ADDENDUM NO. 2
TO THE CONTRACT DOCUMENTS

Date: September 18, 2018
CH2M HILL Project No.: 691267

for the
Brooks Bridge Water Main Replacement for the Okaloosa Island Water Supply Project

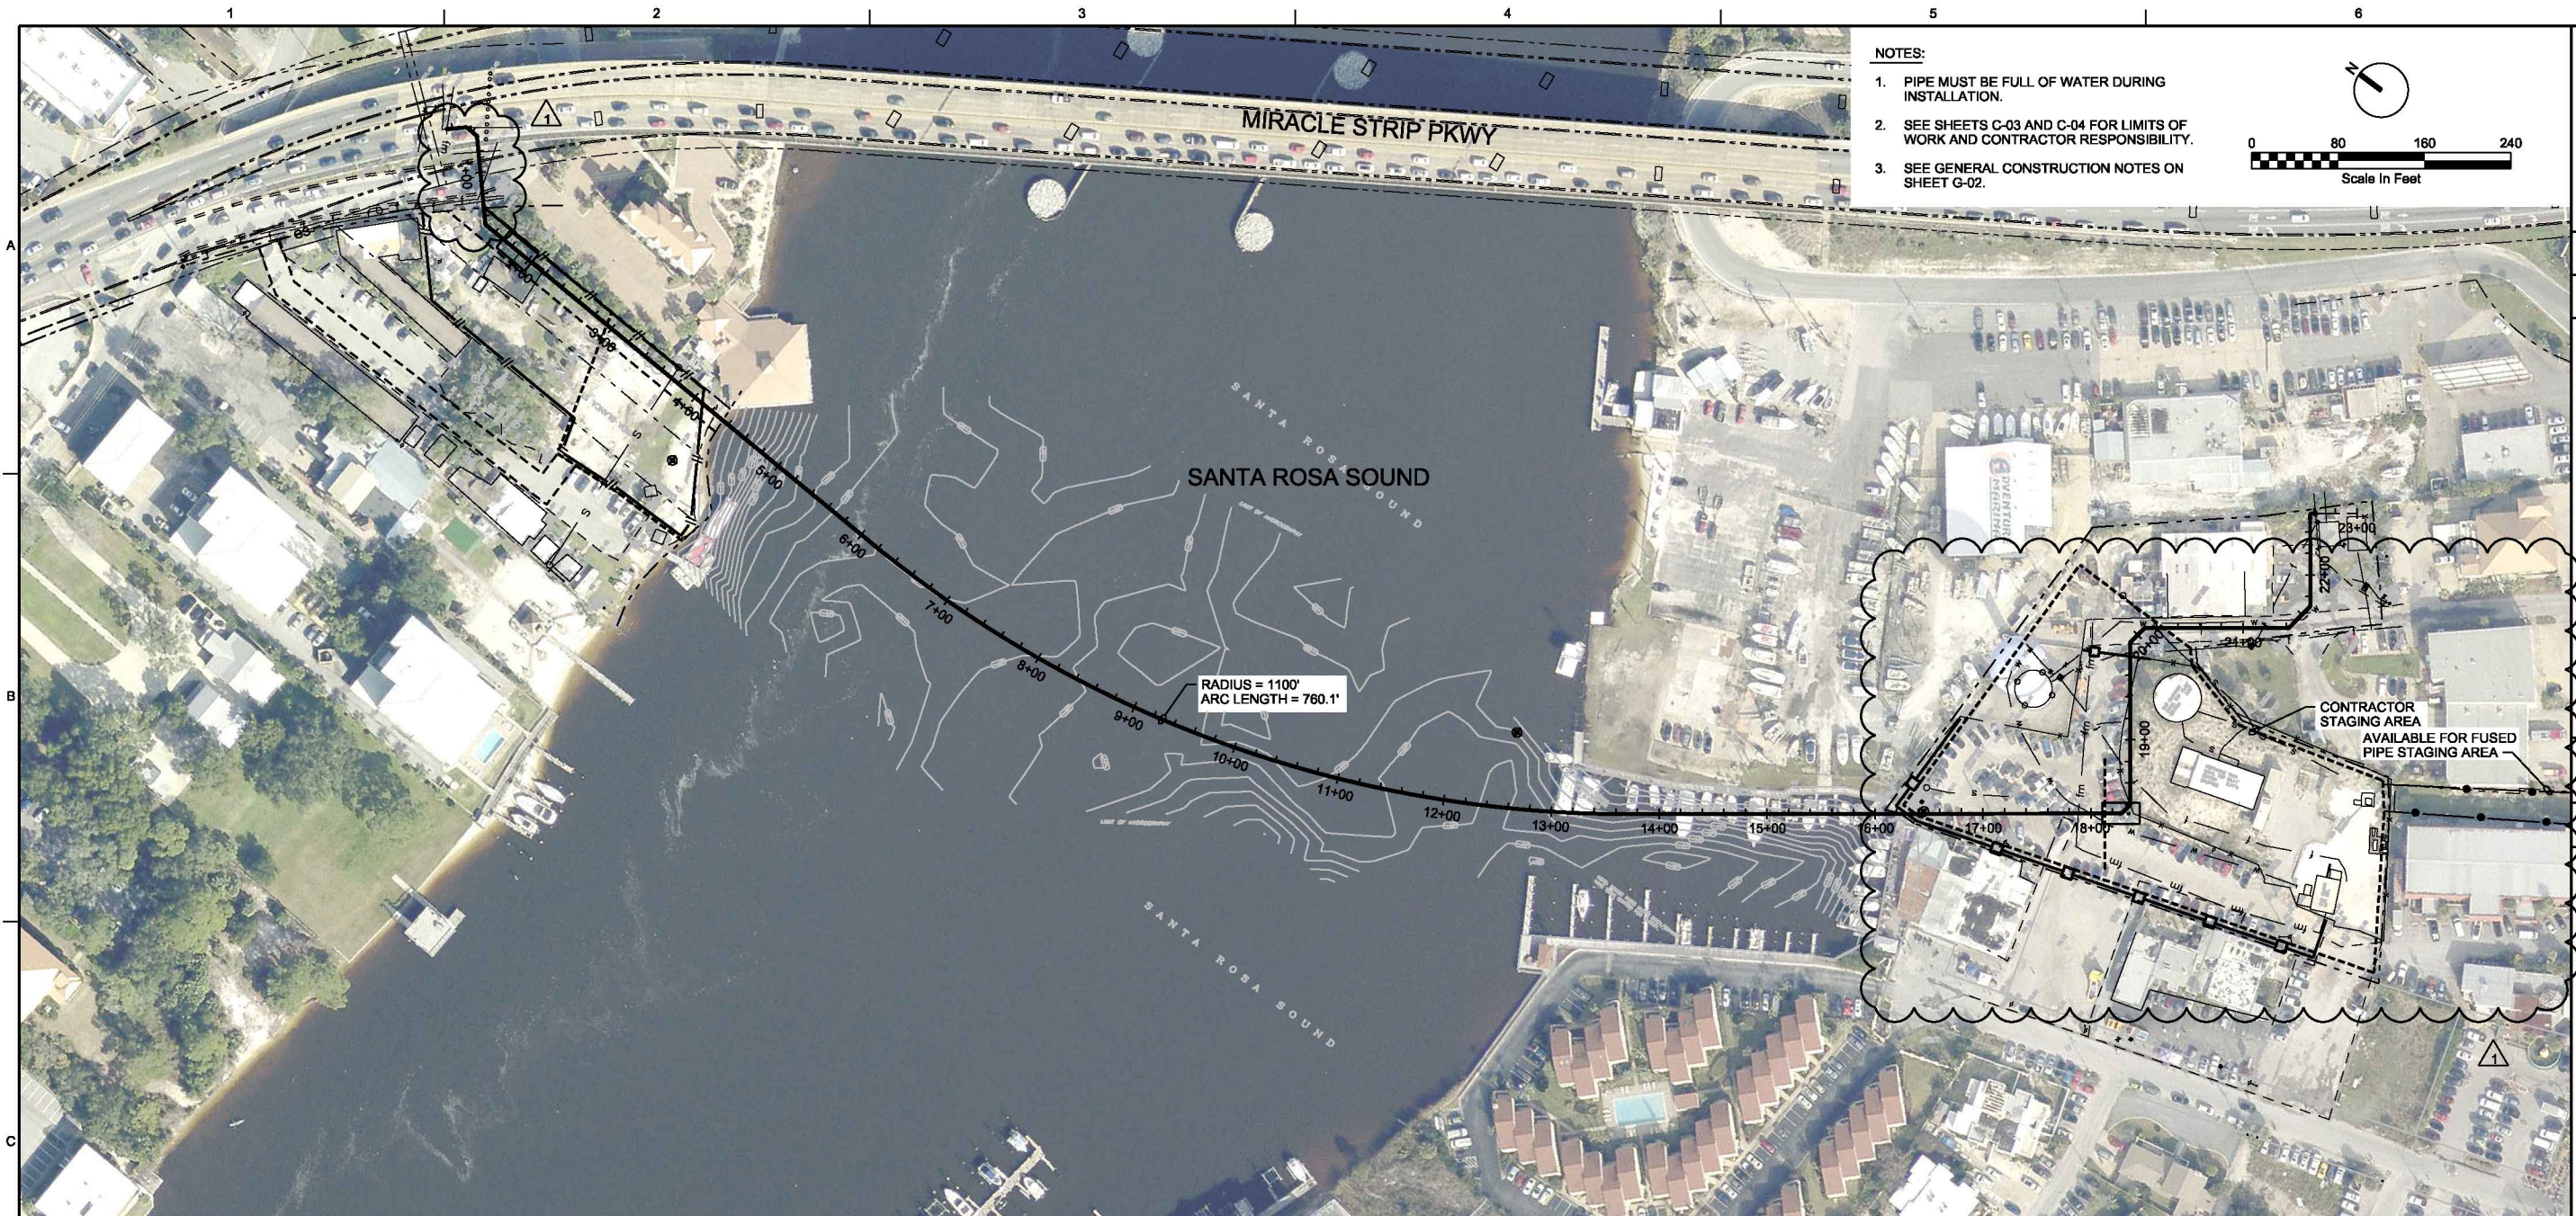
- NOTES:**
- FUSED PIPE STAGING ALIGNMENT OPTION IS SHOWN. CONTRACTOR TO SUBMIT PROPOSED STAGING PLAN ALONG WITH TRAFFIC CONTROL PLAN. CONTRACTOR TO PROVIDE TRAFFIC CONTROL AND TEMPORARY ACCESS WHILE STAGING FOR FUSED PIPE. PROVIDE MEANS OF INGRESS AND EGRESS TO ALL RESIDENCES AND BUSINESSES DURING CONSTRUCTION.
 - SEE SHEET C-03 AND C-04 FOR LIMITS OF WORK AND CONTRACTOR RESPONSIBILITY.
 - SEE GENERAL CONSTRUCTION NOTES ON SHEET G-02.

VERIFY SCALE	
BAR IS ONE INCH ON ORIGINAL DRAWING.	
DATE	AUGUST 2018
PROJ	691267
DWG	C-02
SHEET	of

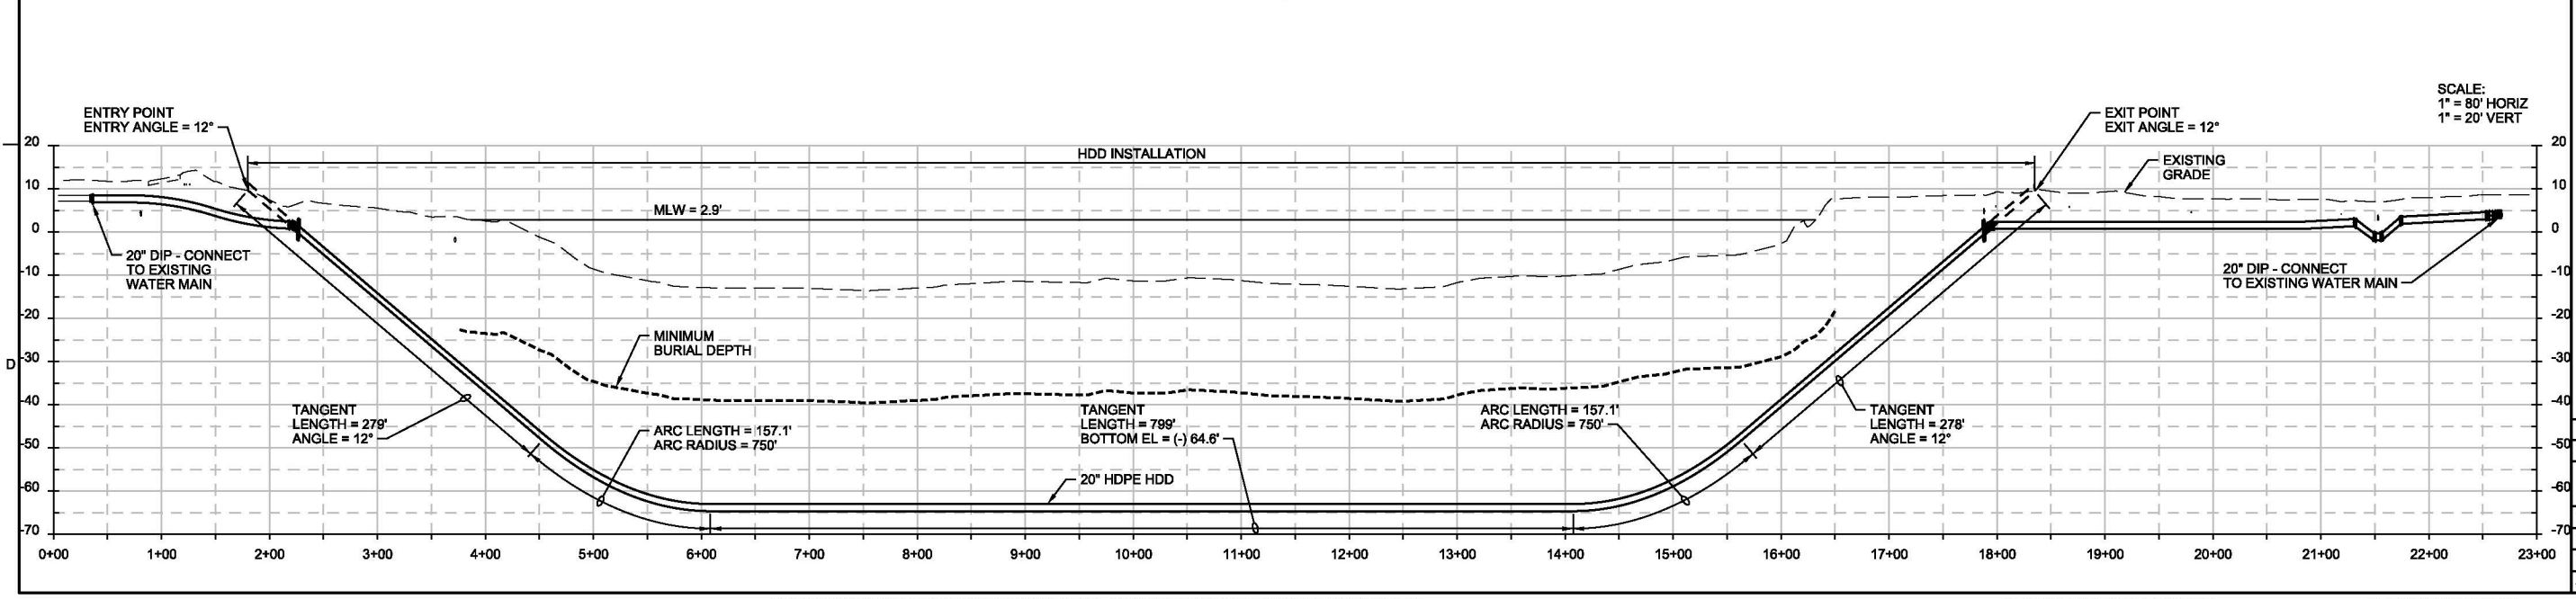
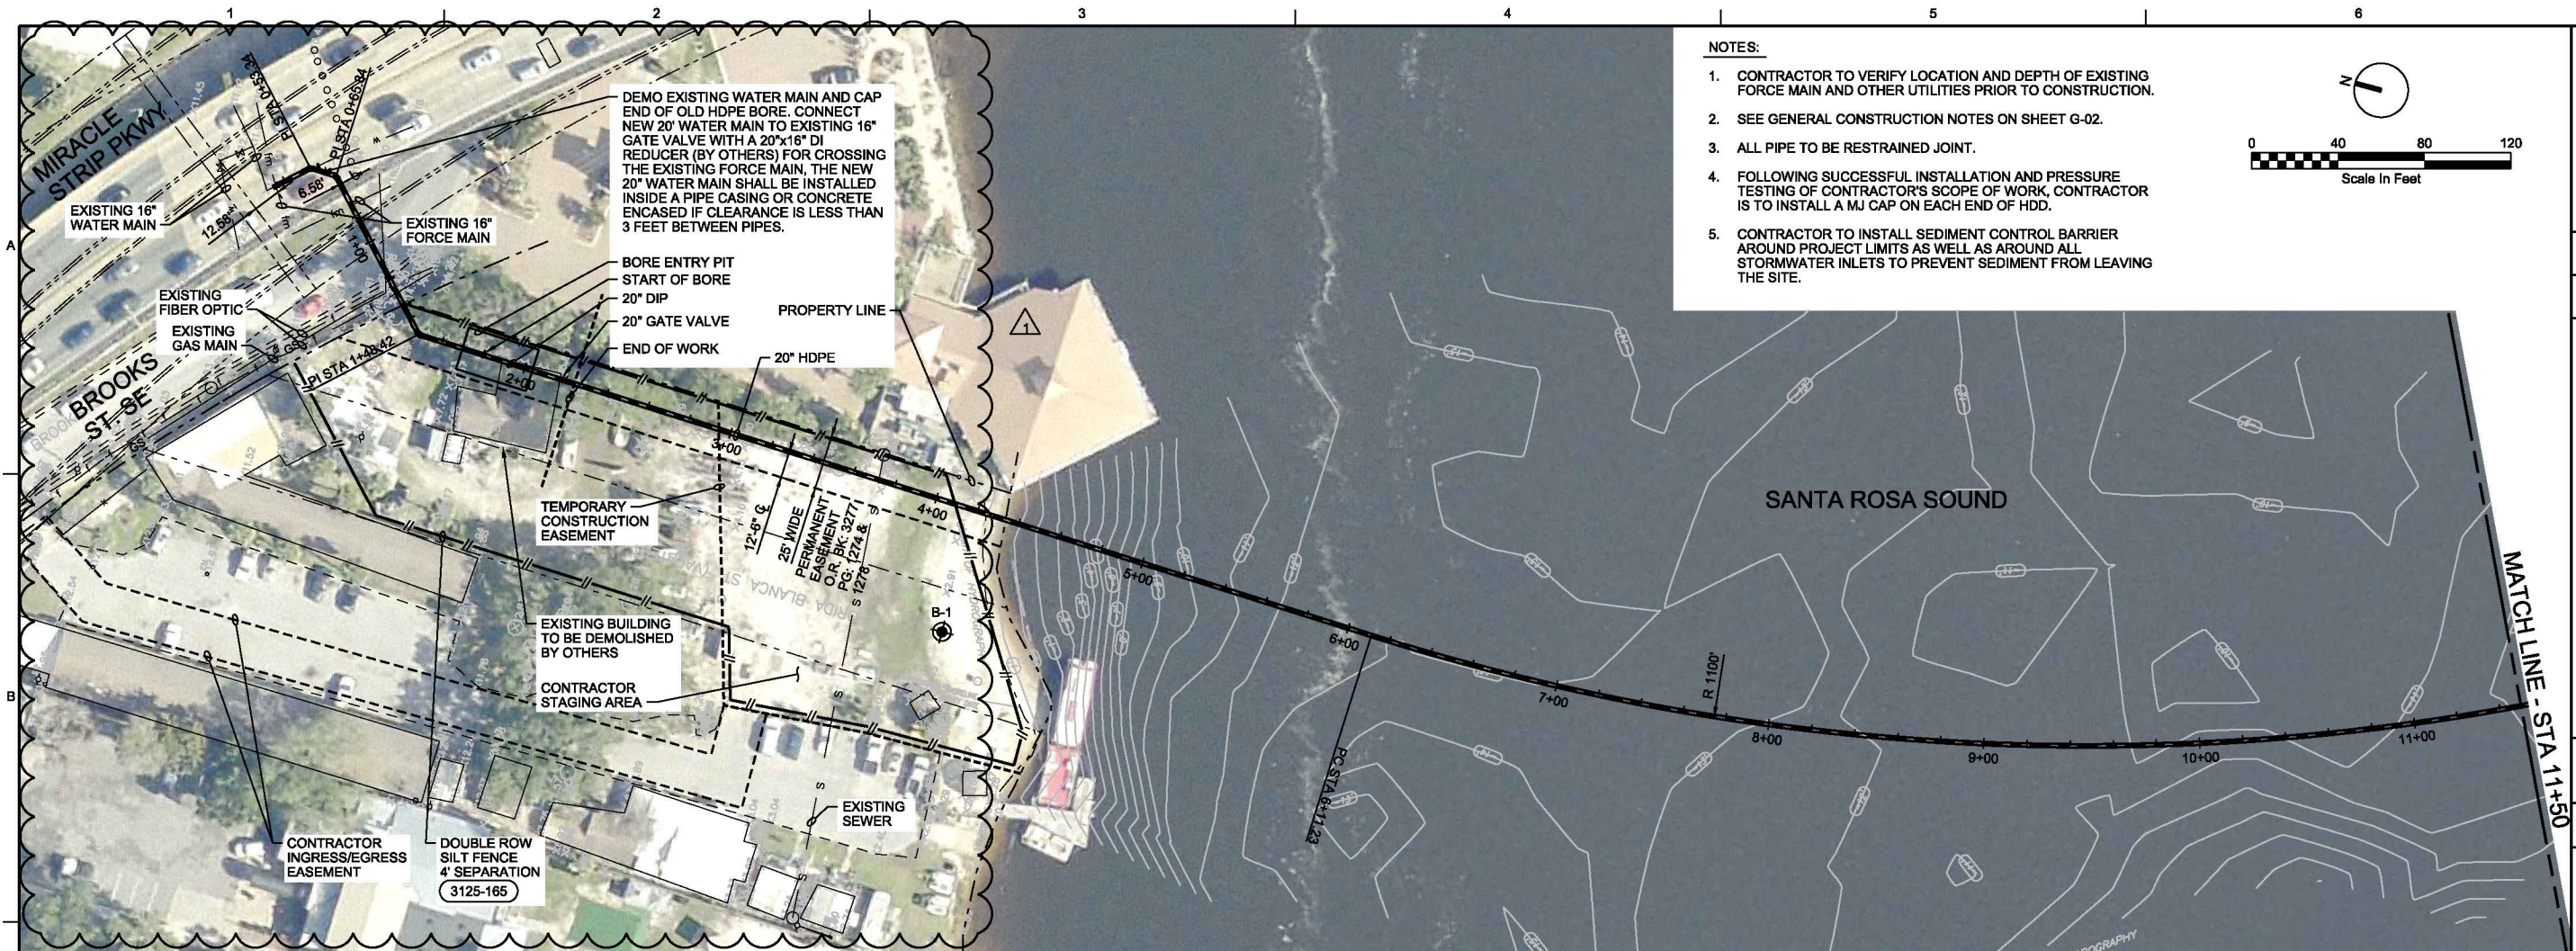
- NOTES:**
1. PIPE MUST BE FULL OF WATER DURING INSTALLATION.
 2. SEE SHEETS C-03 AND C-04 FOR LIMITS OF WORK AND CONTRACTOR RESPONSIBILITY.
 3. SEE GENERAL CONSTRUCTION NOTES ON SHEET G-02.
